SEAD-59 AND SEAD-71

PROJECT SCOPING PLAN FOR PERFORMING A CERCLA
REMEDIAL INVESTIGATION/FEASIBILITY STUDY (RI/FS) AT
THE FILL AREA WEST OF BUILDING 135 (SEAD-59), AND THE
ALLEGED PAINT DISPOSAL AREA (SEAD-71), SENECA ARMY
DEPOT ACTIVITY

APRIL 1997

**PROJECT SCOPING PLAN
REMEDIAL INVESTIGATION/FEASIBILITY STUDY
AT SEAD-59 and SEAD-71
SENECA ARMY DEPOT ACTIVITY
ROMULUS, NEW YORK**

FIGURE 1-2
SITE PLAN

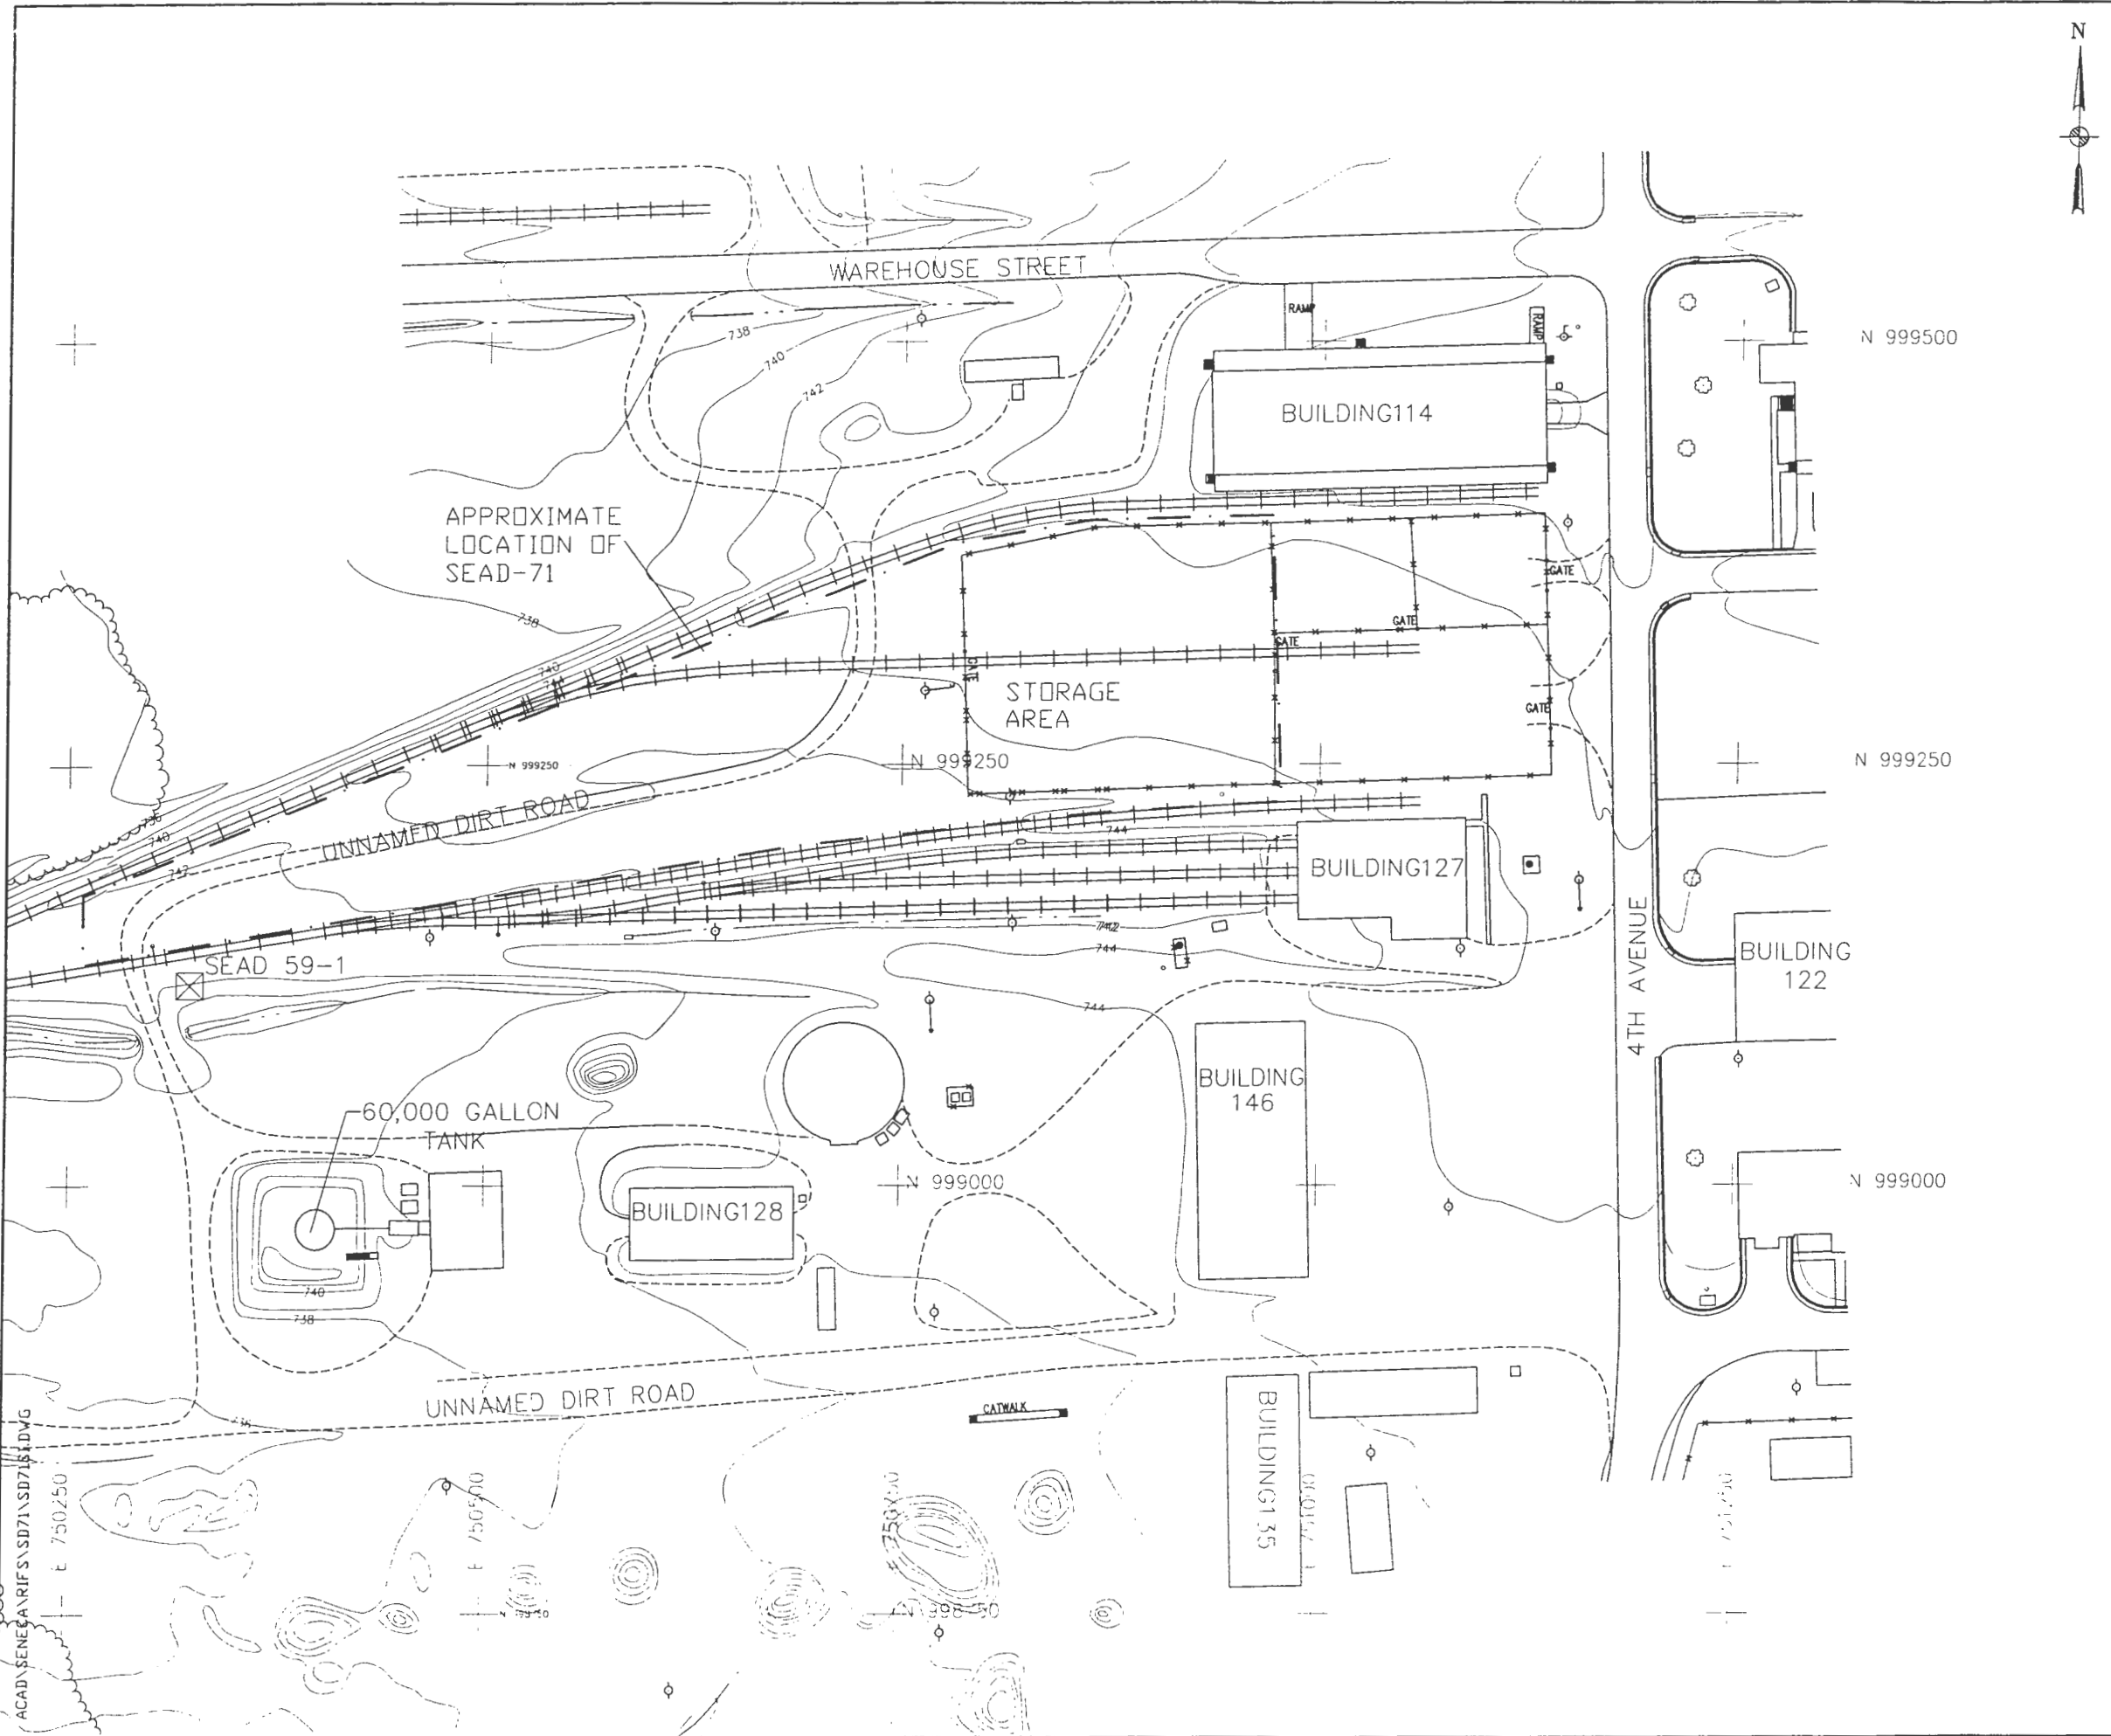
Comment #1 Figure 1-3: Based on the results of Test Pit TP59-1 (BTEX of 2,100,000 ug/kg) the area of the AOC delineated in Figure 1-3 should be expanded.

Response #1 Agreed. The extent of the area that defines SEAD-59 has been extended to the south as recommended in the comment. Figure 1-2 (formerly Figure 1-3) has been revised.

FIGURE 3-7
GROUNDWATER ELEVATION MAP

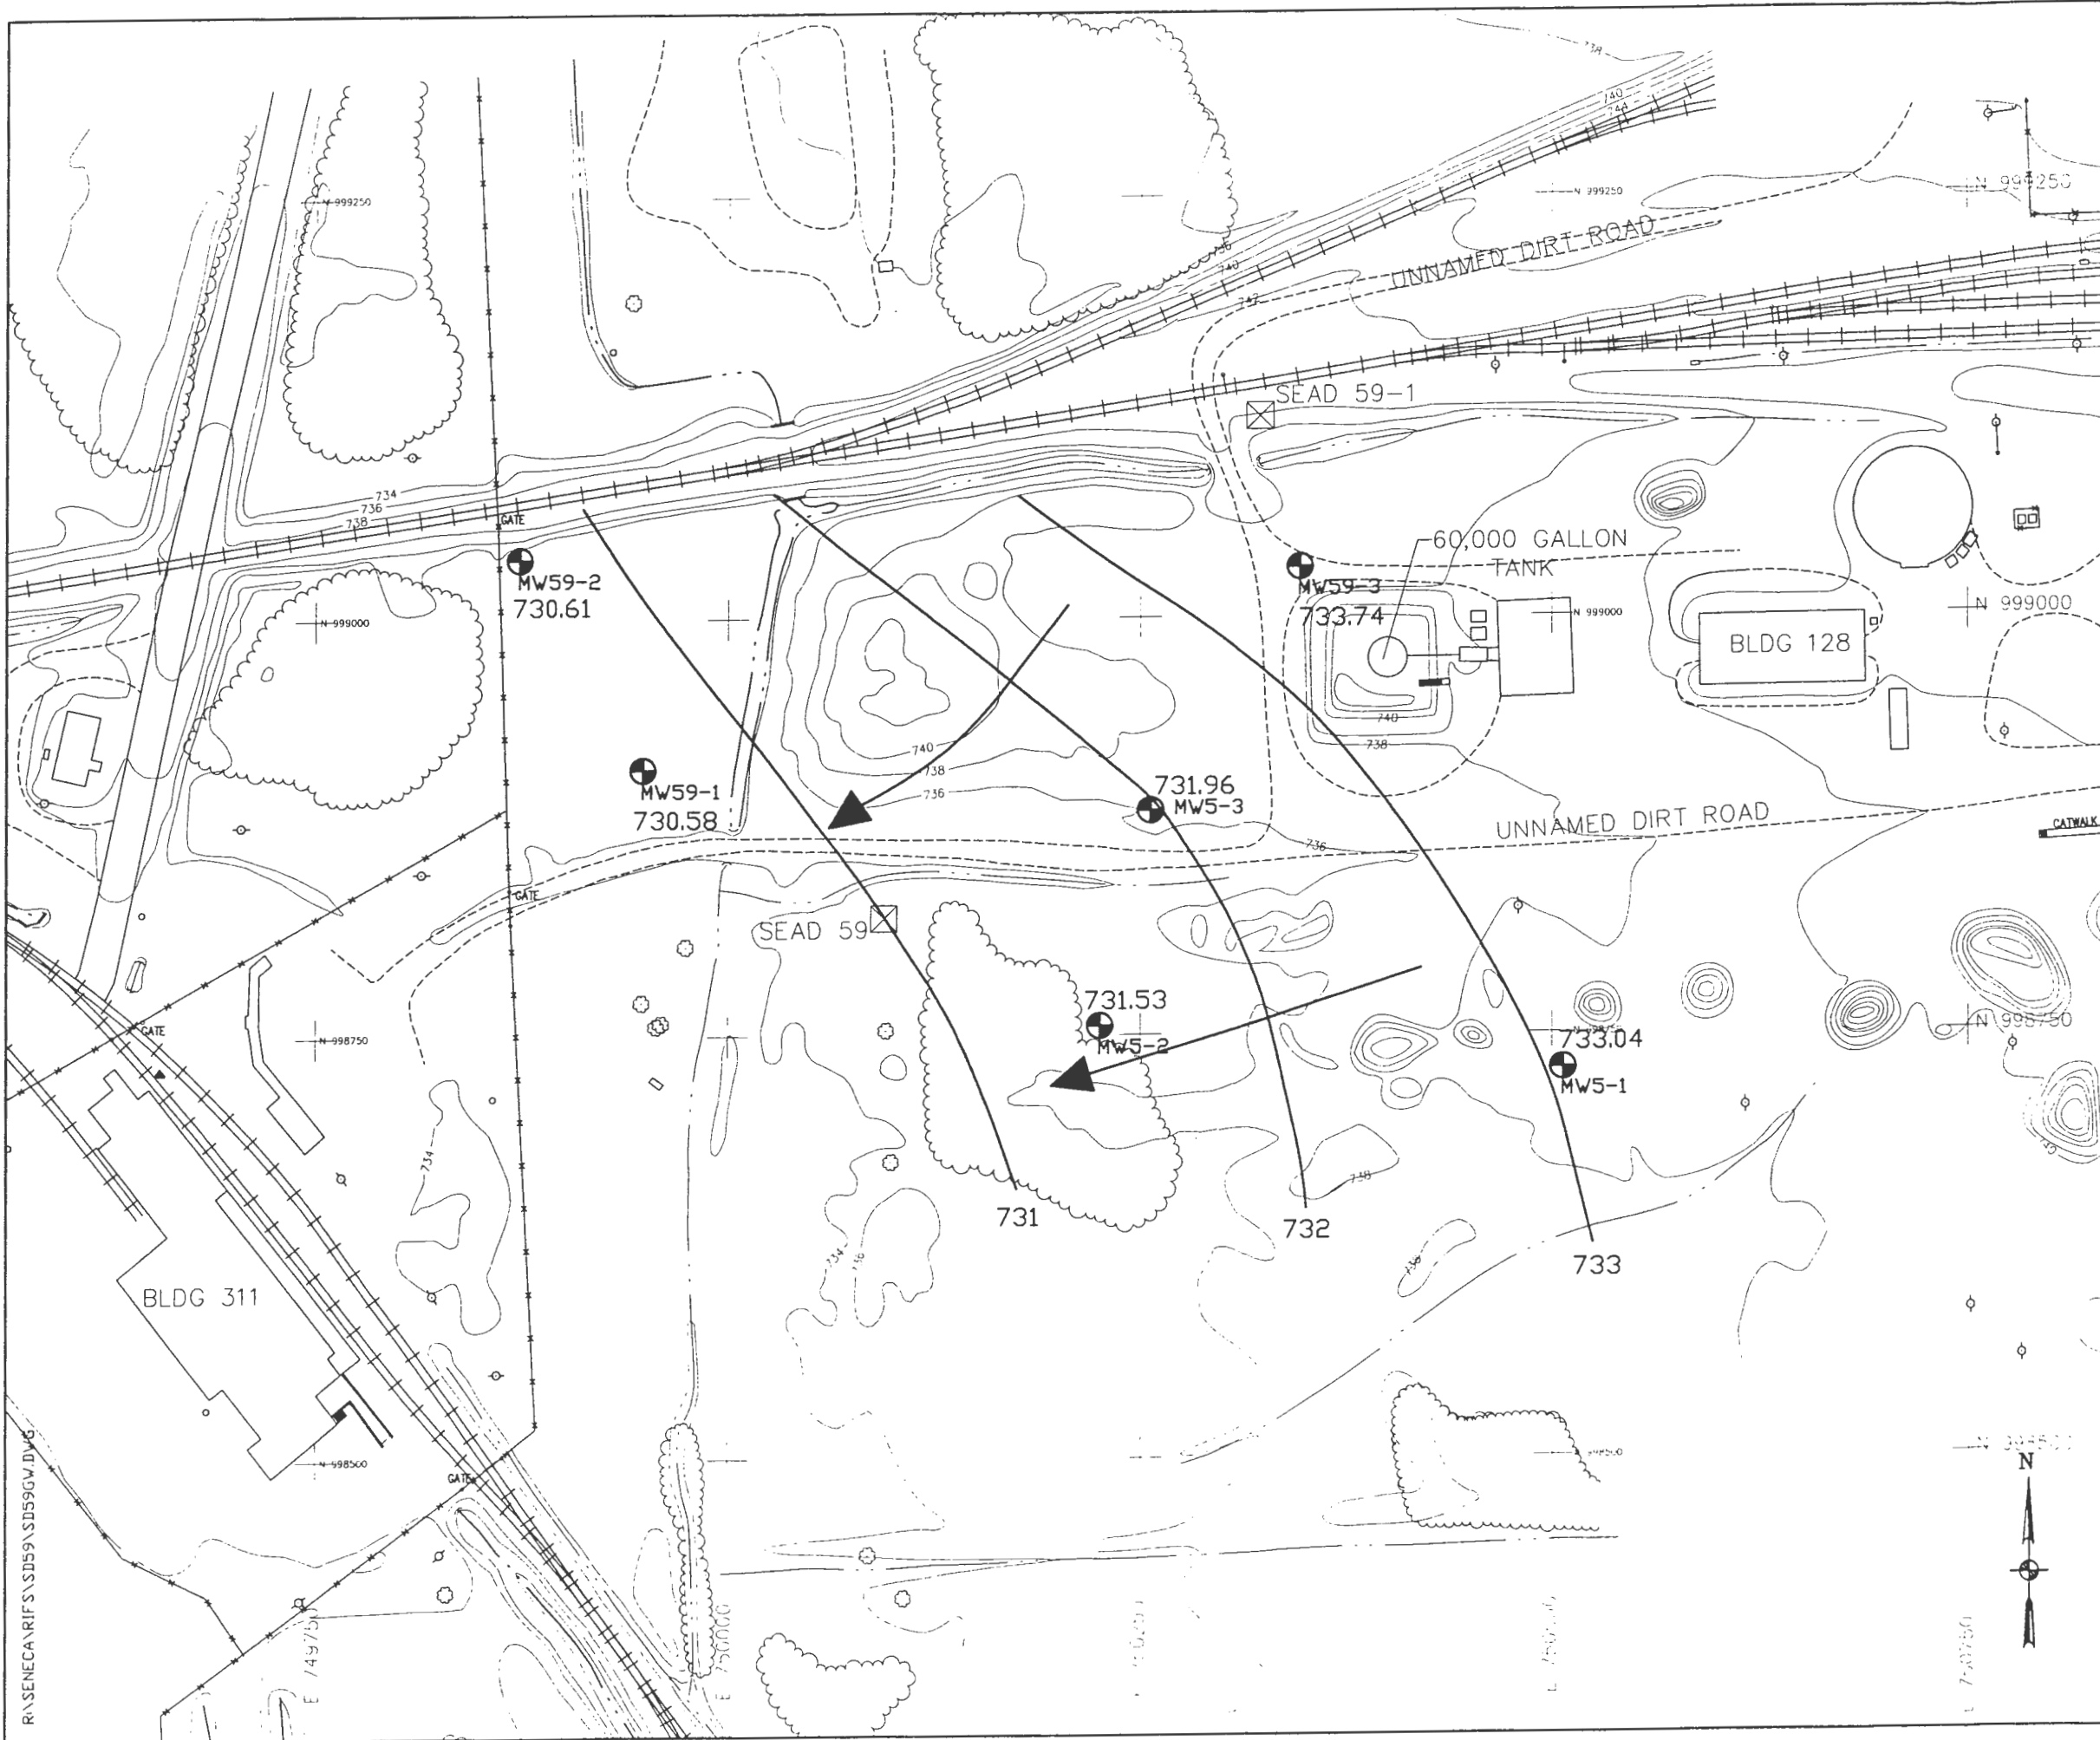
Comment #2 Figure 3-11: It is unclear what control was used to construct the 730 foot contour line presented on this figure. This same comment was made in the EPA's November 28, 1995 letter commenting on the Draft ESI Report for the Eight Moderately Low AOCs. In response to this comment the 730 foot contour was removed in the Draft Final version of this document.

Response #2 Agreed. The 730 foot contour was removed from Figure 3-7 (formerly Figure 3-11) as recommended in the comment.

FIGURE 3-9
 TOTAL PAHs IN SURFACE SOILS
 LOCATION OF ESI SAMPLING POINTS

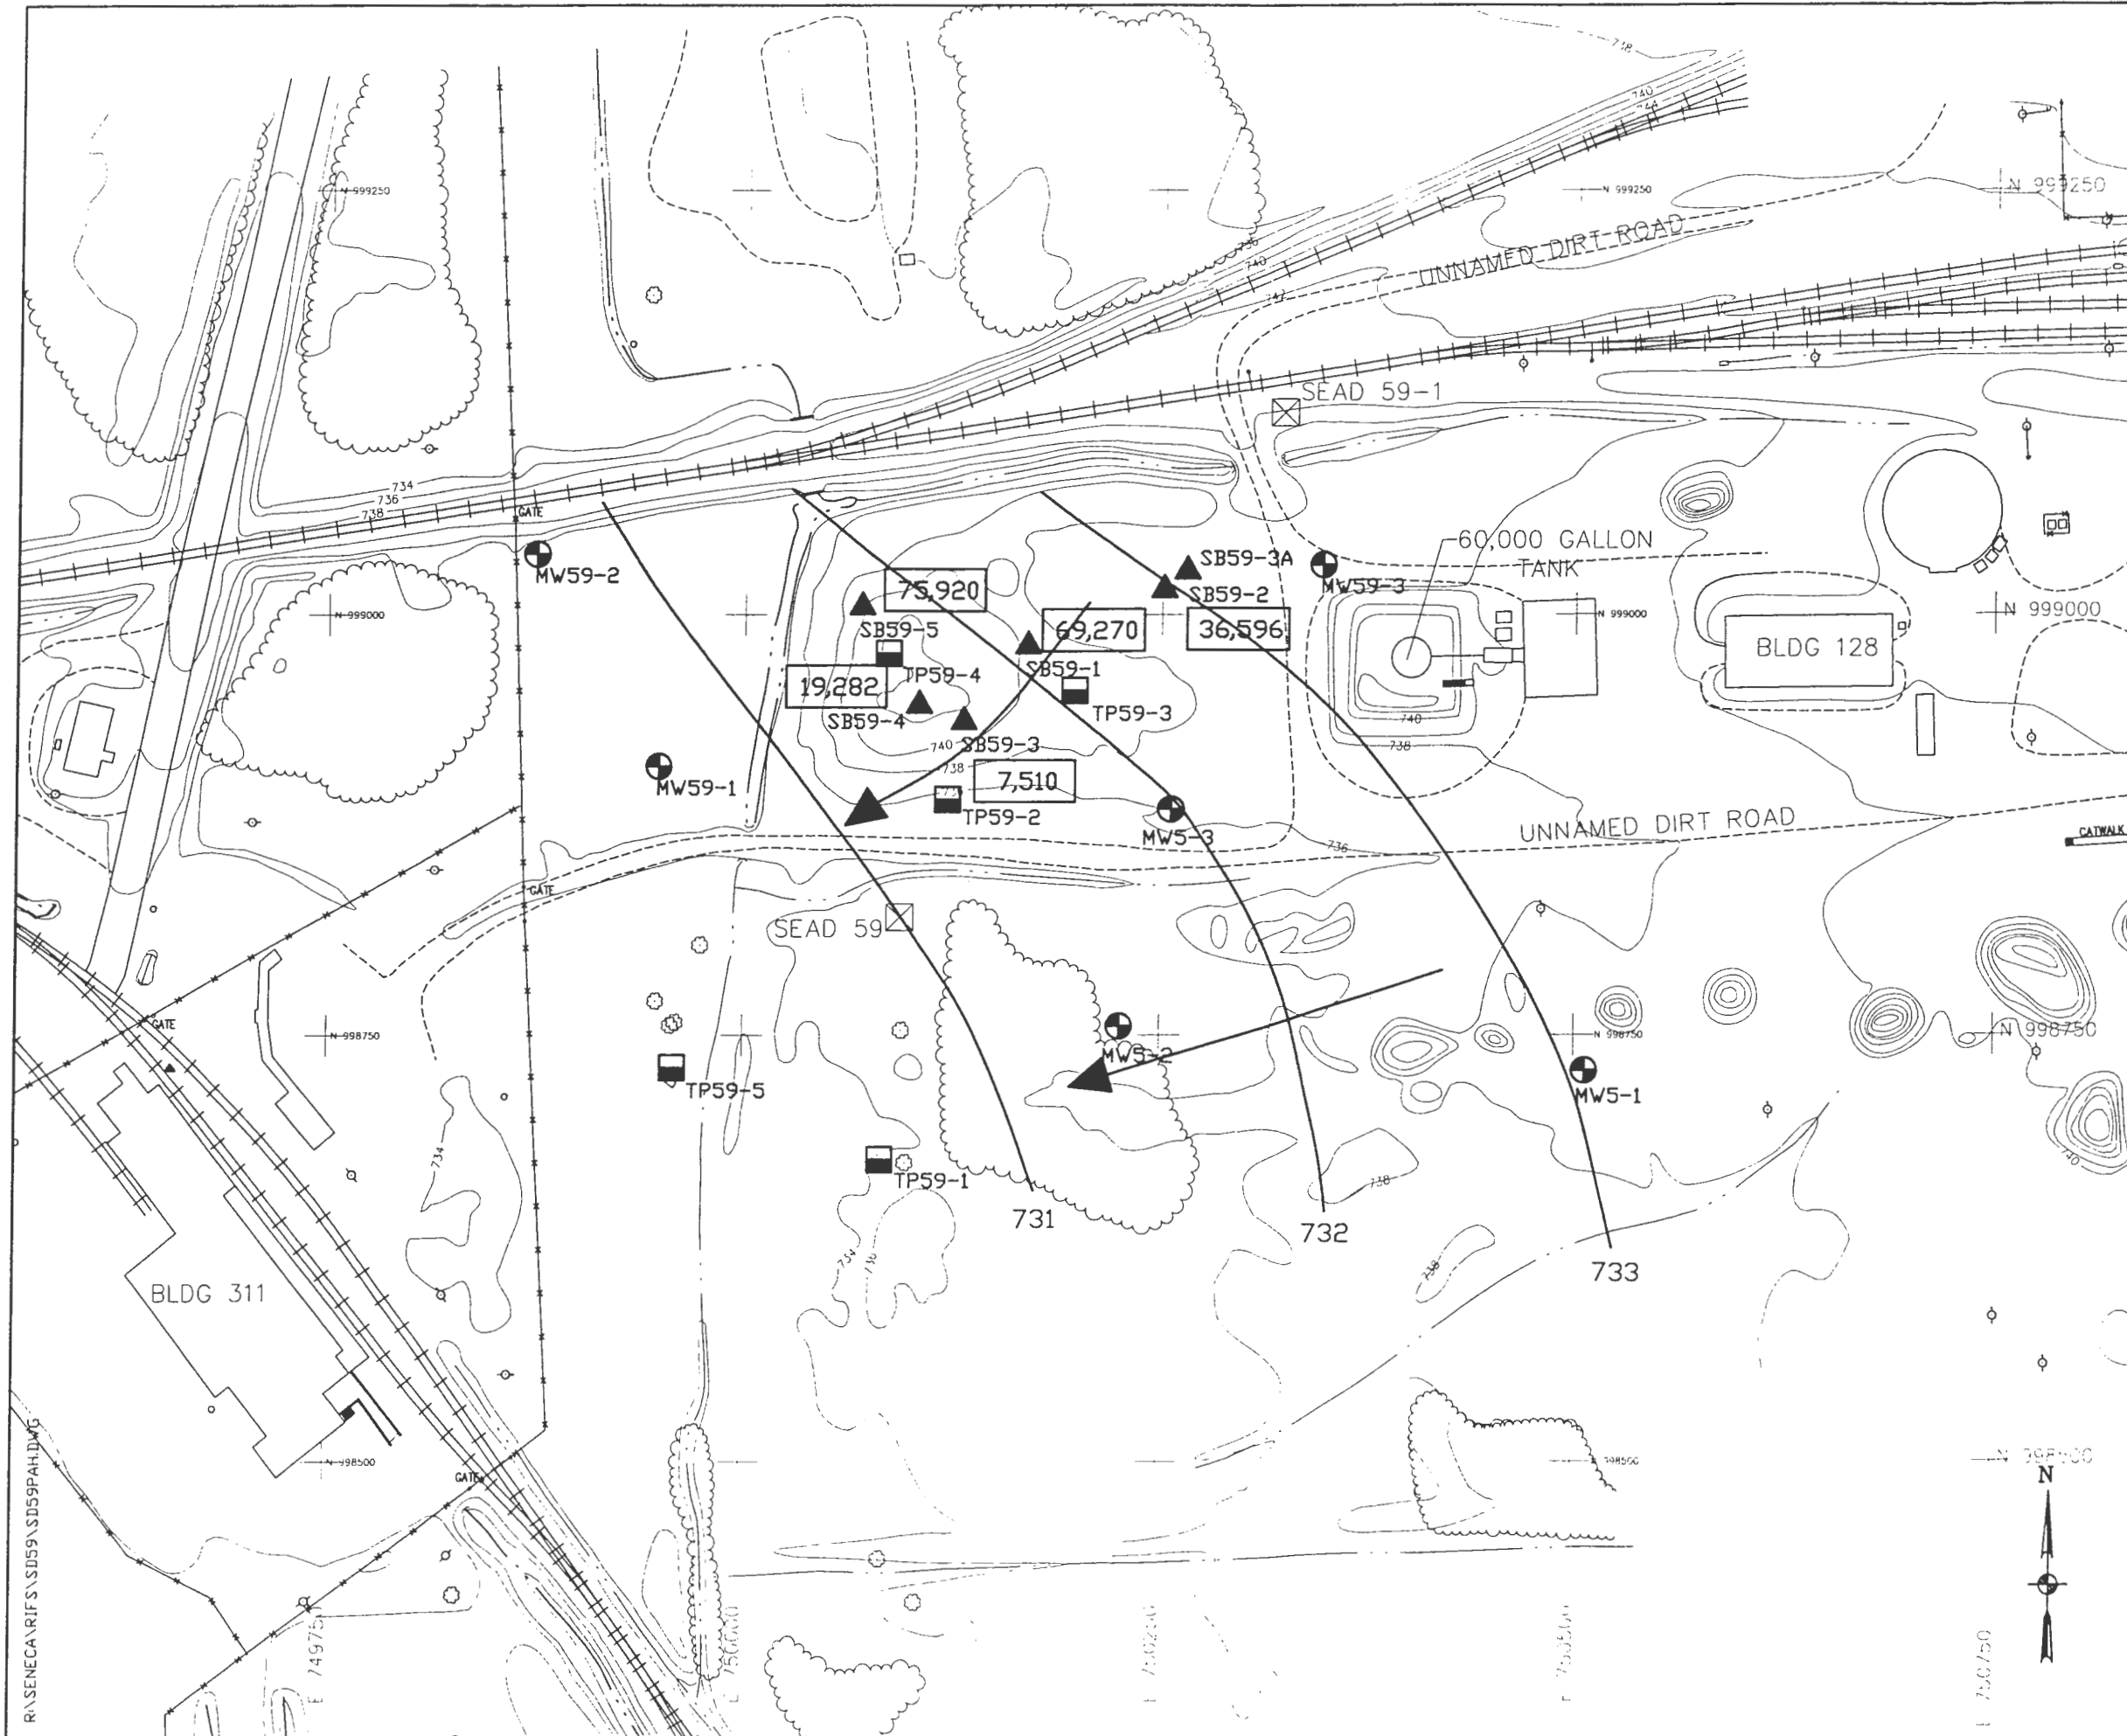
Comment #3 Figure 3-13: Monitoring wells MW5-1, MW5-2, and MW5-3 should be shown on this Figure as they are on Figure 3-11 and Figure 3-12.

Response #3 Agreed. Monitoring wells MW5-1, MW5-2, and MW5-3 were added to Figure 3-9 (formerly Figure 3-13) as recommended in the comment.
